Flight Procedures Cover Page	Task Action: FLIGHT CHECK	Task Type: IAP	Estimated Chart Date: 03/19/2026	APWS Task ID: A99E33FF59314851B44A821A073CC07F	APWS Project ID: 57BF7E49DA214FB4BC657A95CE7B6330
Procedure: RNAV (GPS) RWY 18 AMDT 3		Enroute: NO	Specialist: Purnell, Troy		Agreement Number:
Airport ID: KFSO			Airport City: HIGHGATE		State: VT
Facility ID:	Facility Type:	Flight Inspection Remark Type: Hold FC Slot

PROCEDURE: RNAV (GPS) RWY 18 AMDT 3		AIRPORT NAME: FRANKLIN COUNTY STATE		AIRPORT ID: KFSO	SPECIAL CONTROL NO: YG-11-038-25
FAC ID: KFSO18.03		CITY: HIGHGATE		ST: VT	ORIG CHART DATE: 03/19/2026
DFL TYPE: PROC/W	THIRD PARTY: <input type="checkbox"/> YES	EST. TIME ON SITE: 0.4	REIMB. NUMBER:	PTS TASK ID: A99E33FF59314851B44A821A073CC07F

PROCEDURE RESULTS

RNAV (GPS) RWY 19

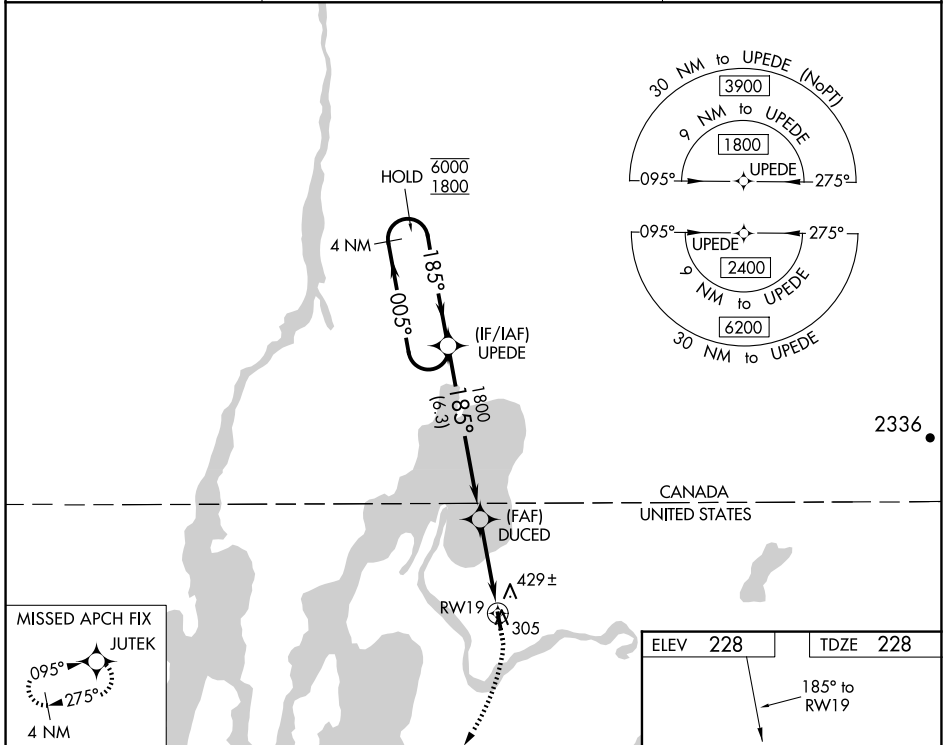
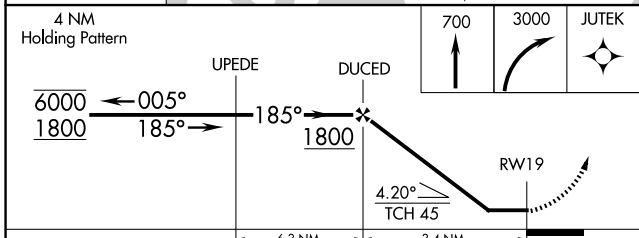
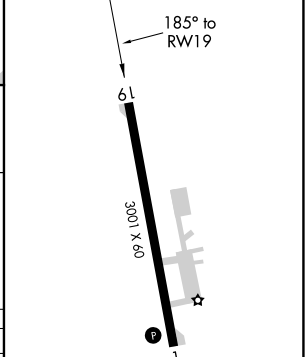
FAS data in the procedure and the ARINC data use different data. Procedure needs rejected.

- S file states "PENDING AIRNAV DATA 03/19/2026 USED FOR KFSO"
- The AIRNC data is using the 02/18/2027 data
- The procedure FAS data uses the 03/19/2026 data.
- The length offset is incorrect
- o Procedure package length offset = 1528
- o AIRNC data length offset = 1832
- Either the procedure needs updated to use 02/18/2027 data or the ARINC data needs updated to us 02/18/2027 data
